APPLICATION NO.: HM/A-21:139

SUBJECT PROPERTY: Municipal address **231 Walter Ave. S., Hamilton**

Proposed Section 19
Basement Conversion
231 Walter Avenue
Hamilton, ON.

Minor Variance Application for 231 Walter Ave S, Hamilton (File No. HM/A-21:139) clarification/revisions to the plans:

SHEET TITLE
SP1-01 SITE PLAN

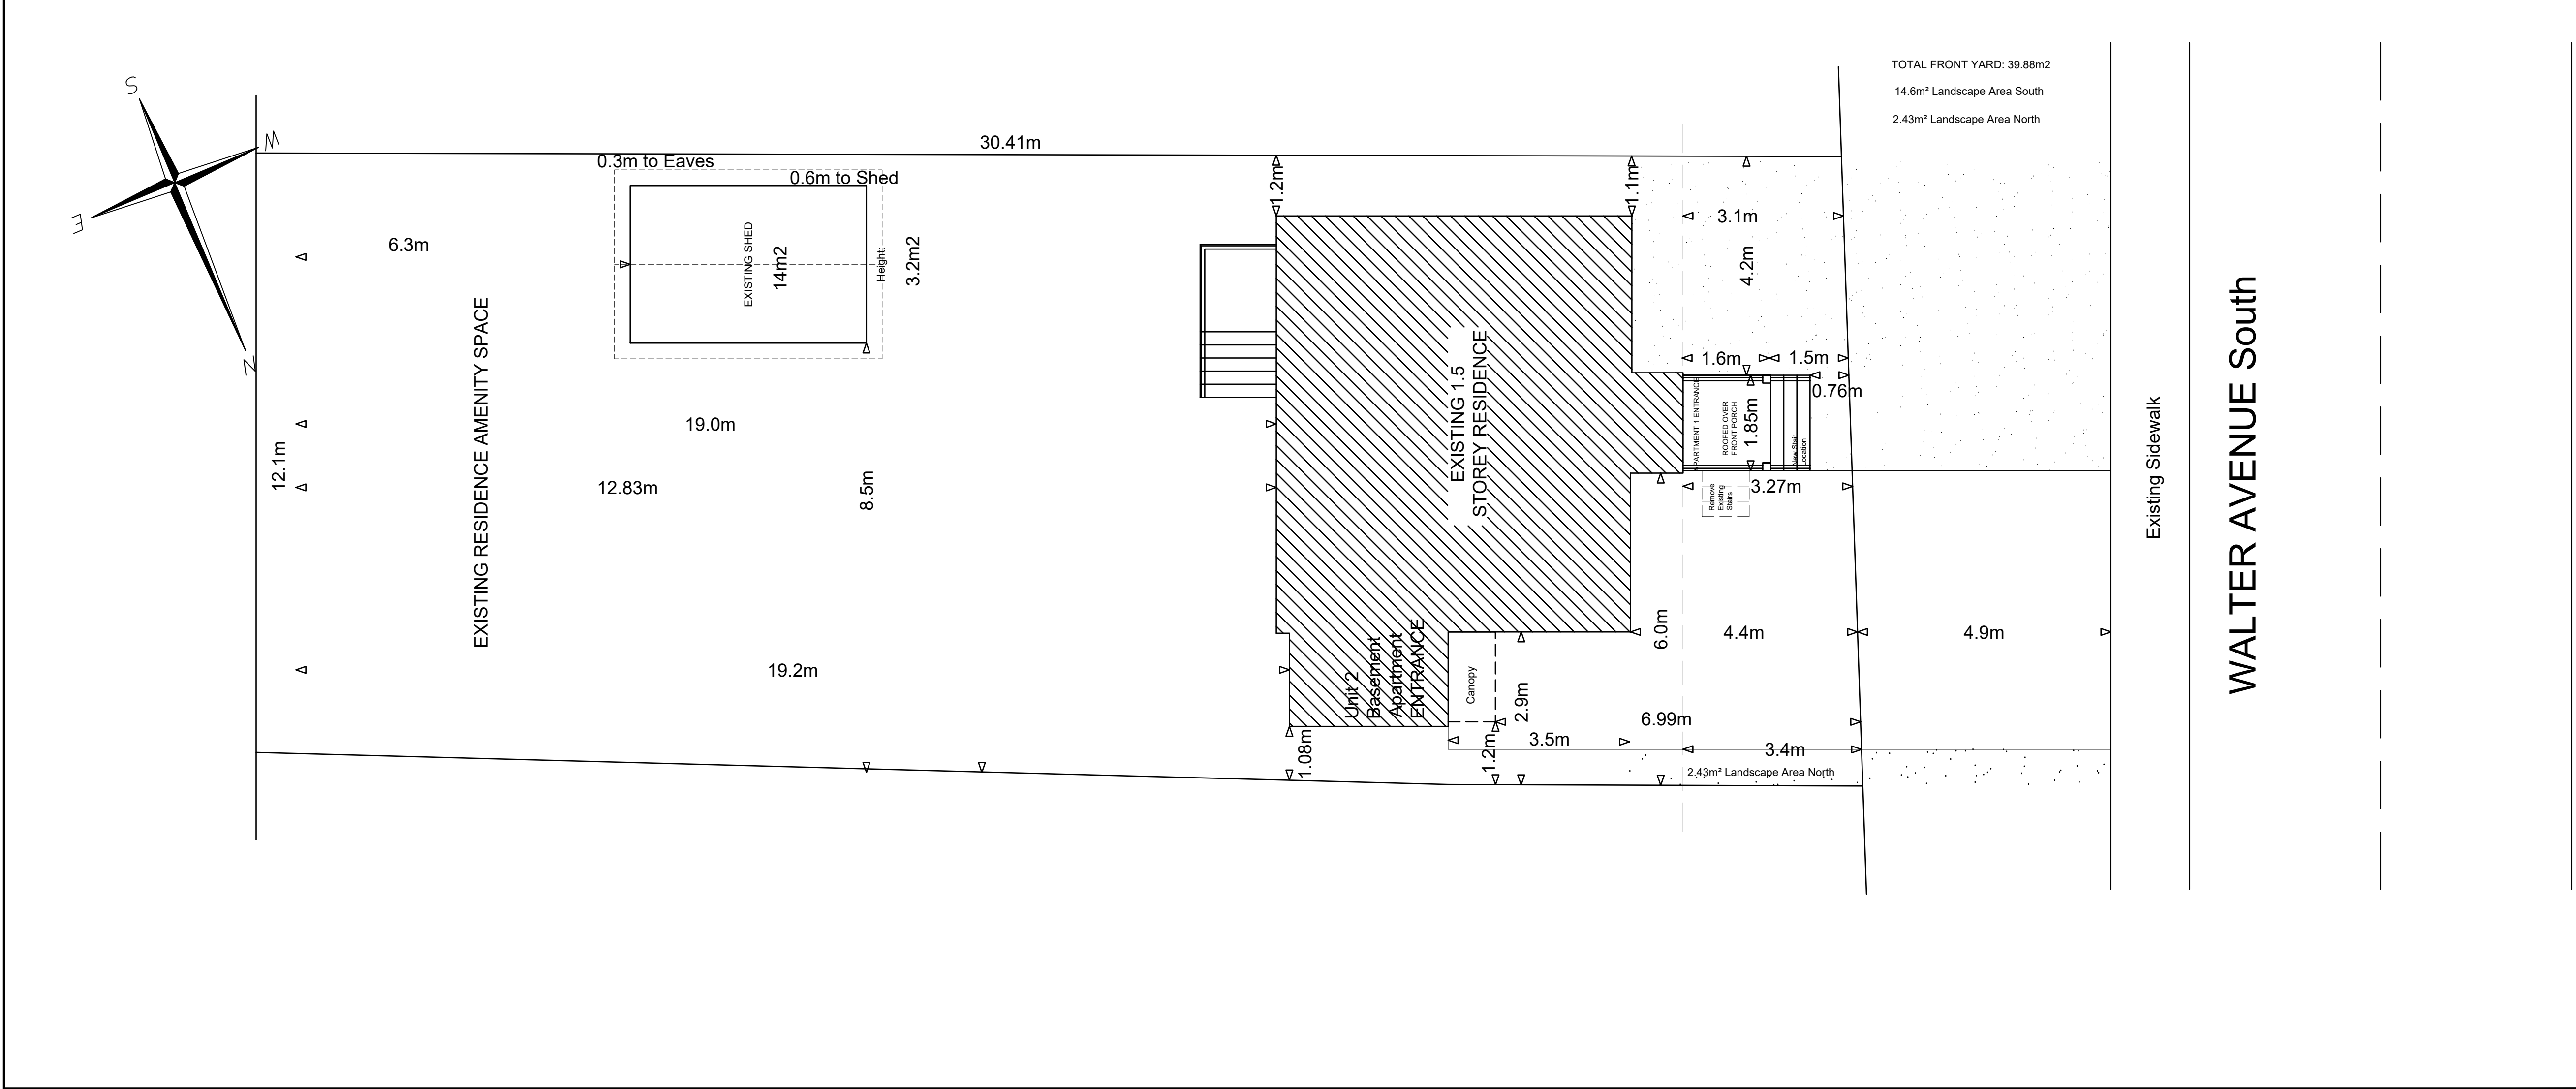
- 1) The building setbacks shown on the Site Plan submitted do not match a 1979 survey in Building Division records. As such, it is suggested that you may wish to obtain a copy of this survey so that correct setbacks are shown including the setback to the re-located porch steps and the location of the porch to the basement dwelling unit (Apt 2). I have attached a copy of the City's Property Records Request form.

- 3) Please reconfirm the: front yard area, the front yard landscaped area and the front yard driveway area. The front yard is the setback to the closest part of the building to the front lot line which is the bump-out portion which contains the front door to Apt # 1. These numbers should be revised on the Site Statistics.

Further, there are discrepancies respecting the front yard landscaped area as the Site Statistics indicate a "front yard green space area of 23.3m²"; however, the Site Plan shows a 21.3m² landscaped area. Further, the landscaped area dimensions show a 4.63m length x 4.15m width = 19.2m².

- 5) As the steps on the roofed-over unenclosed one storey porch at the first storey to Apt 1 are being relocated, additional information is required to be provided as it appears a variance will be required. Please revise the Site Plan to show the setback of the relocated stairs from the front lot line. SEE DIMENSION ADDED

Further, the roofed-over one storey front porch at the 1st storey to Apt # 2, including its stairs shown on the photo on the Site Plan has not been shown on the Site Plan. As such, please revise

the Site Plan to show this porch, roof and stairs including its setback from the front lot line and north side lot line in order to determine zoning compliance. Also, please indicate required information in the chart below.

- 7) Can you please show the setback of the shed from the south and north side lot lines and the rear lot lines. Further, if this shed had eaves and gutters, please show the setback of the eaves and gutters from the side lot lines and rear lot lines. Additionally, please show the shed height.
SEE REVISED SITE PLAN

WE MEASURED TO THE EXISTING FENCES BUT YES, WE HAVE REQUESTED THE SURVEY

I RECALCULATED THE AREA. SEE SITE STATISTICS

SEE THE 2.0m² STRIP TO THE NORTH SIDE OF THE DRIVEWAY. WE ADDED THAT AS LANDSCAPED AREA. THE REVISED SITE PLAN SHOW THREE AREAS: IN FRONT OF THE BASEMENT APARTMENT 2, THE STRIP TO THE NORTH OF THE DRIVEWAY AND THE "LAWN" TO THE SOUTH OF THE DRIVEWAY.

[SEE DIMENSION ADDED](#)

SHEET TITLE
A2.01 - Main Floor
Conversion

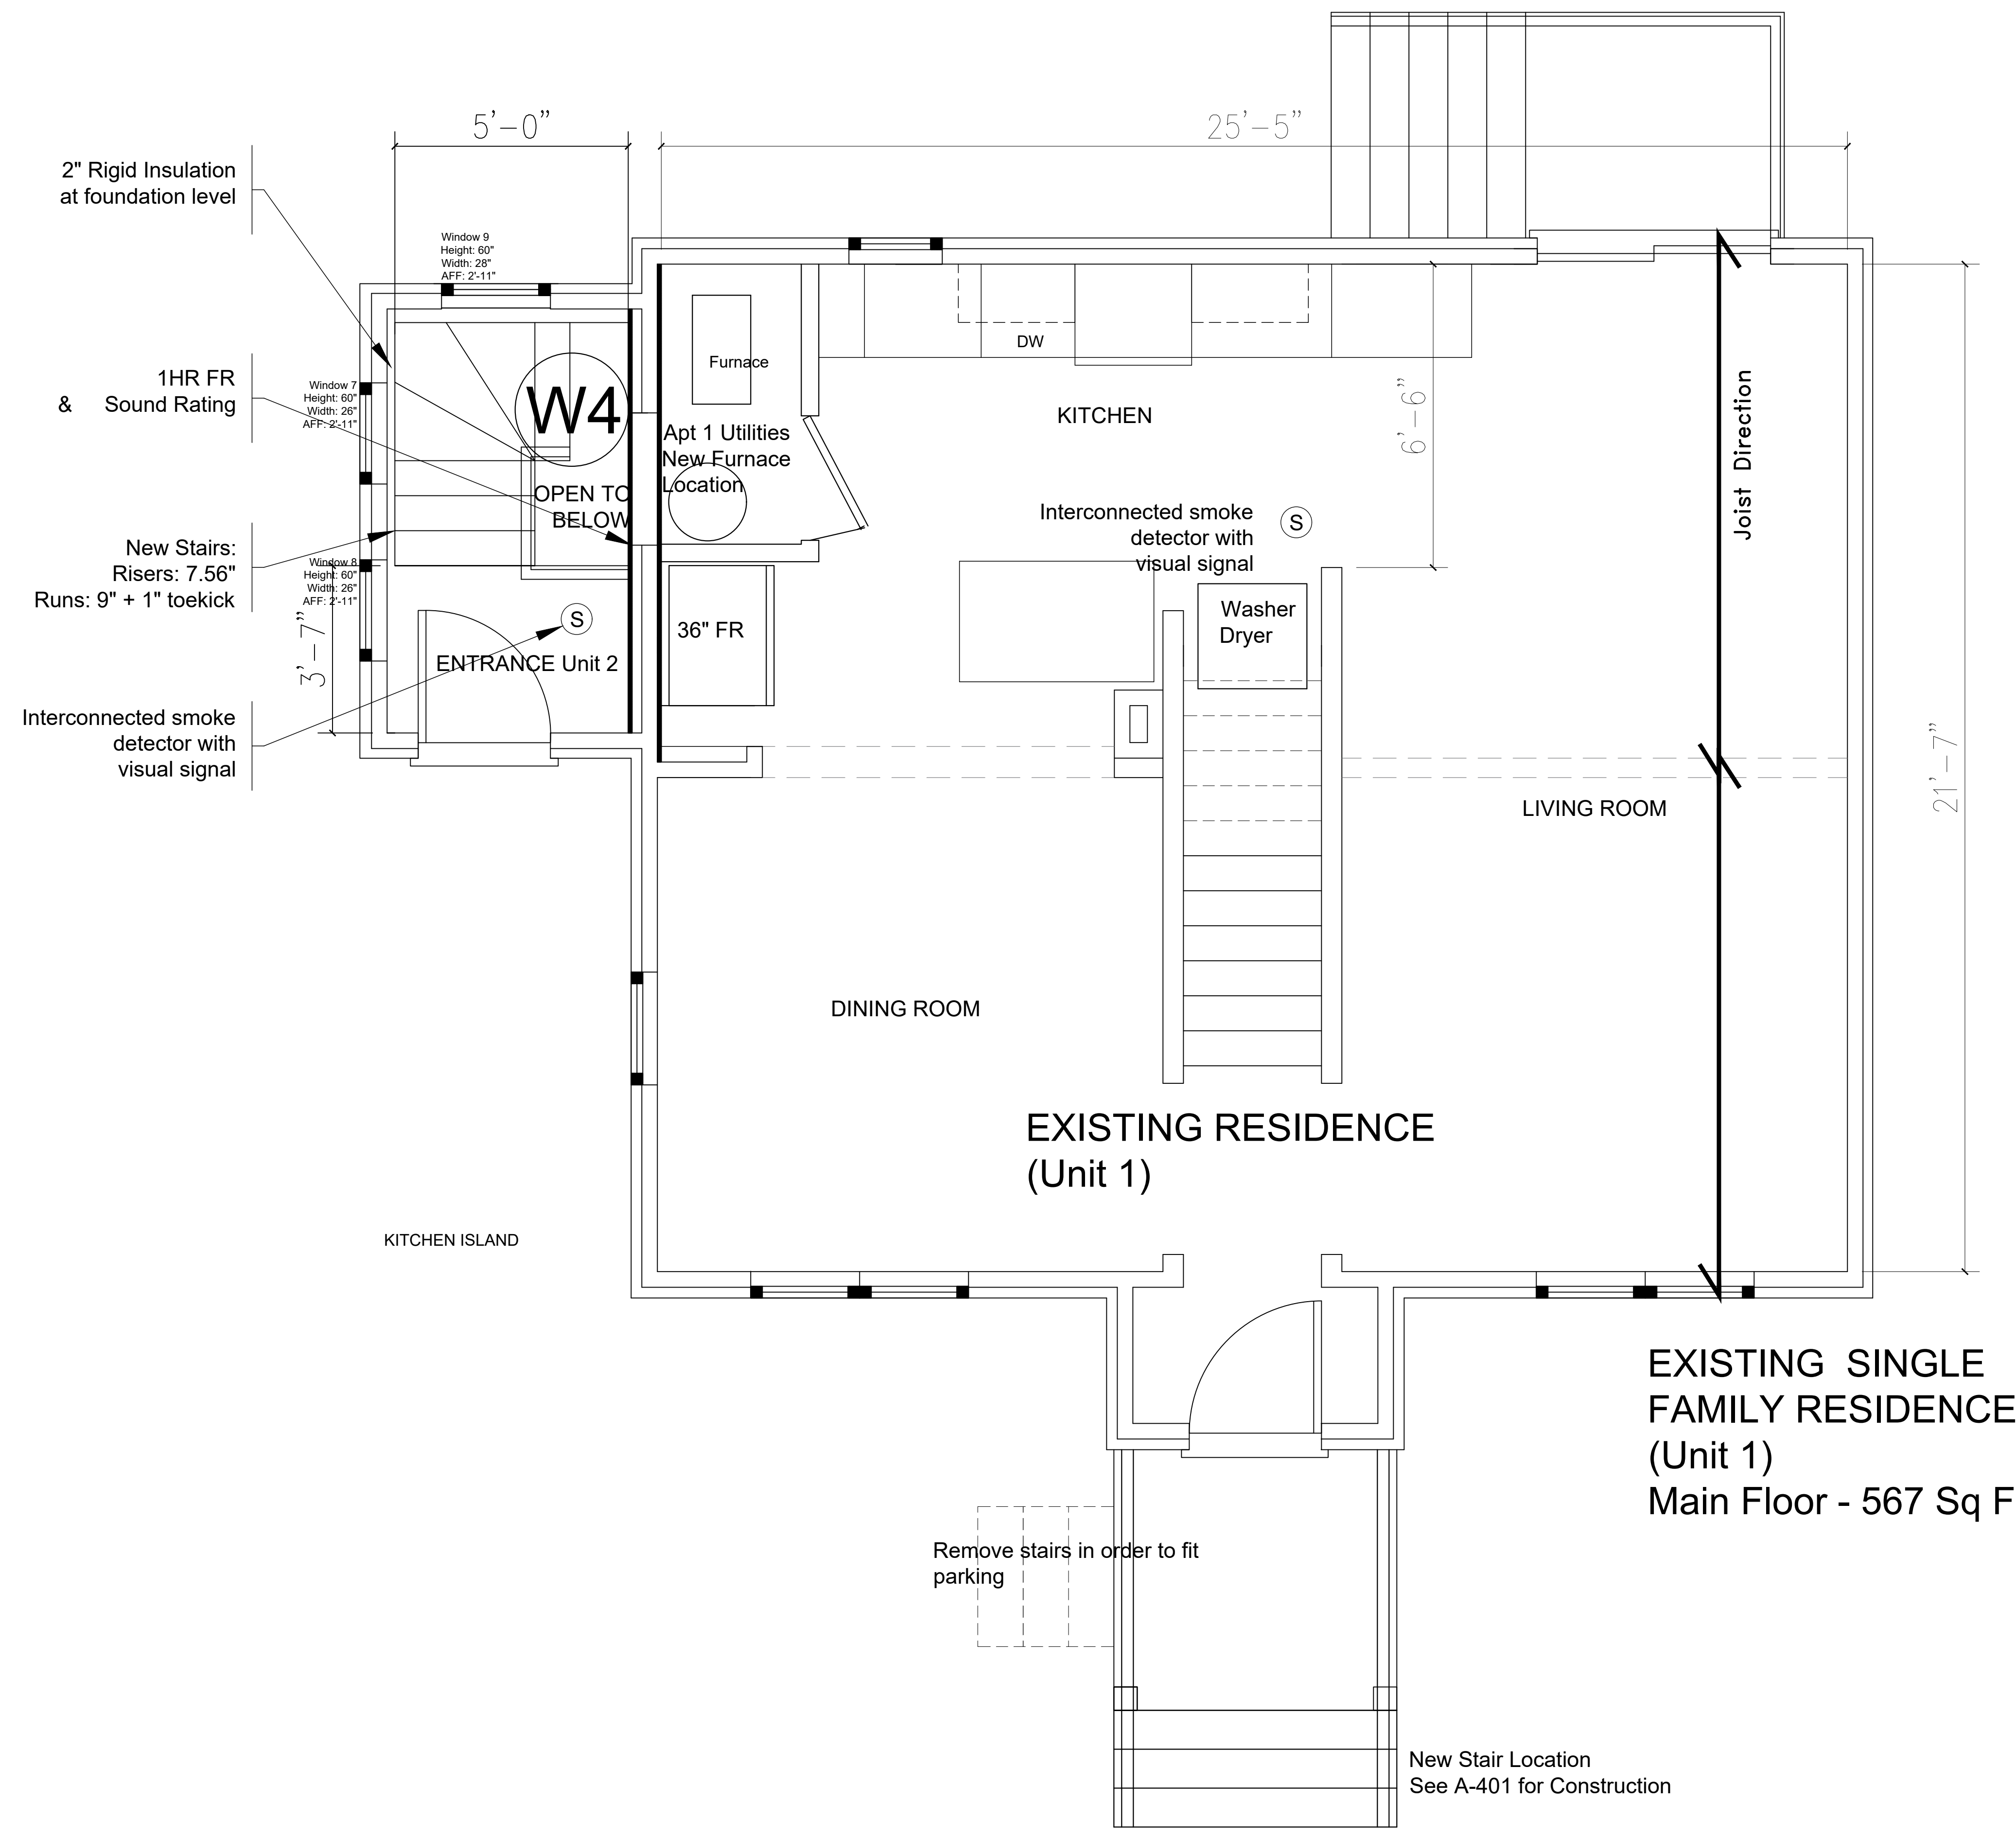
- 2) Drawing A2.01 indicates that the "Basement Apartment Area" includes the stairs and landing. Can you please confirm that this area is only used by this unit and does not include Apt # 1 (Main and 2nd floor unit). The gross floor area of a dwelling unit cannot include any shared spaces.

THE ENTRANCE TO BASEMENT APT 2 IS NOT SHARED AND I INCLUDED THE MAIN FLOOR PLAN TO SHOW.
